CV Version This version is a prototype DIYSynthMNL		
Sheet: / File: Eurorack-3310-ADSR.kicad_sch		
Title: Eurorack AS3310 ADSR		
Size: A3	Date: 2024-02-13	Rev: 0.1.3
KiCad E.D.A. eeschema 7.0.9		Id: 1/1

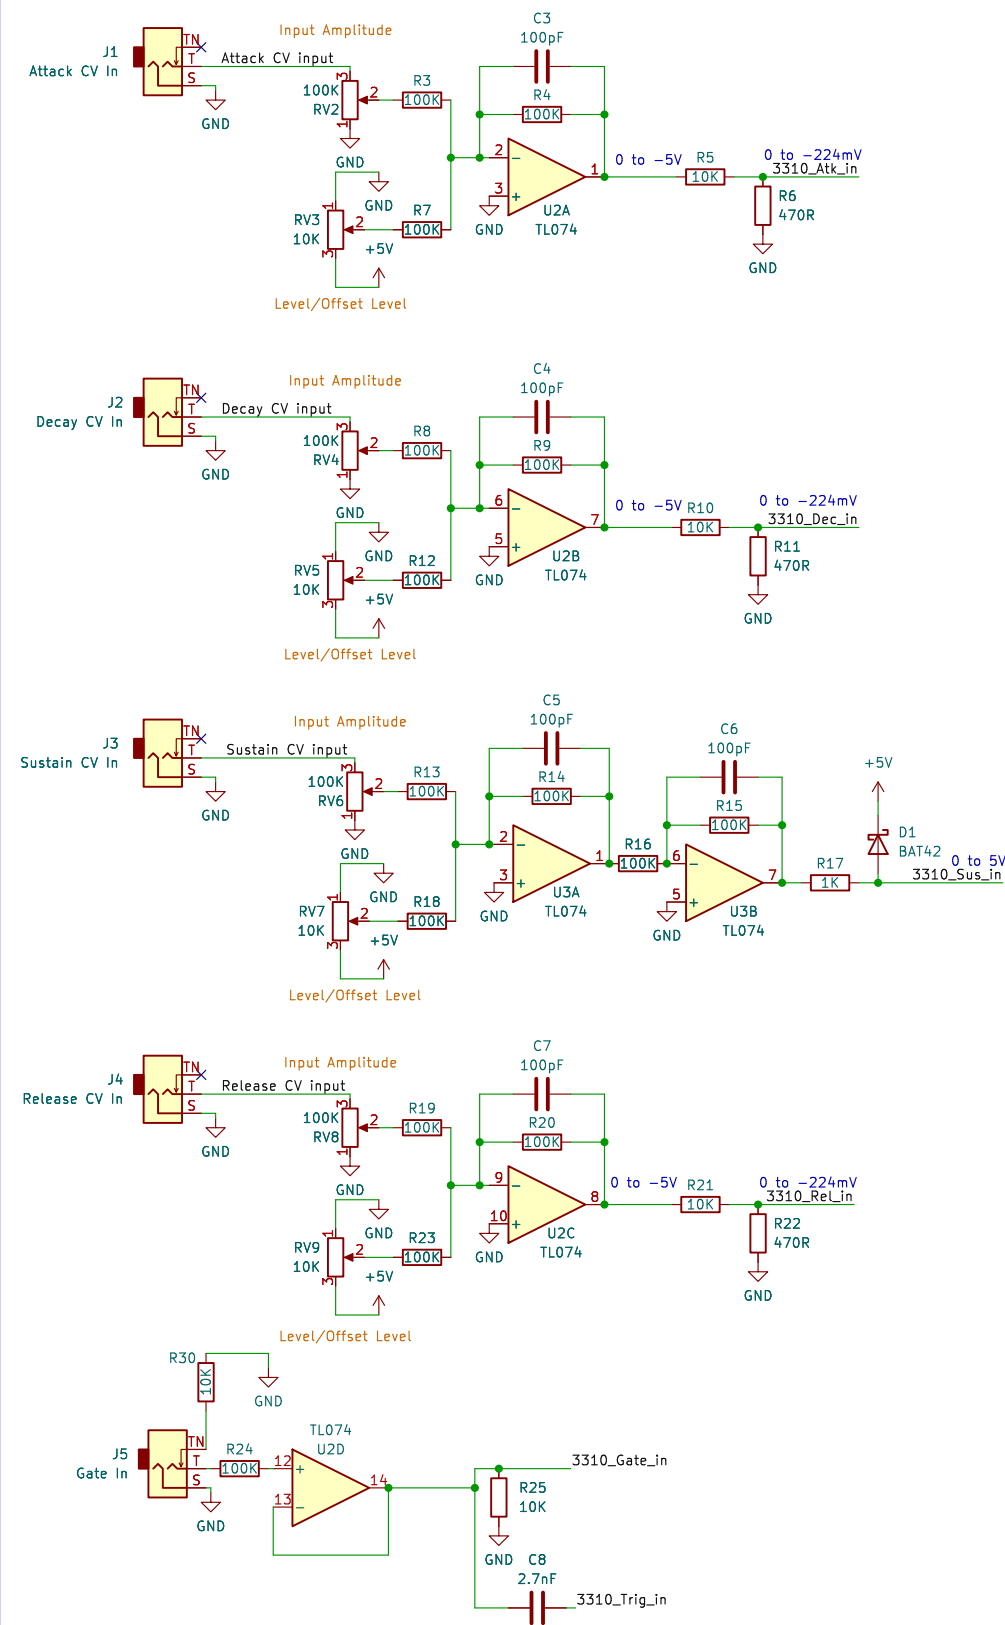
Rev 0.1.3
Changed R2 to from 10K to 16K.
Add value to R27 (1K).
Add R30 to prevent input from floating.
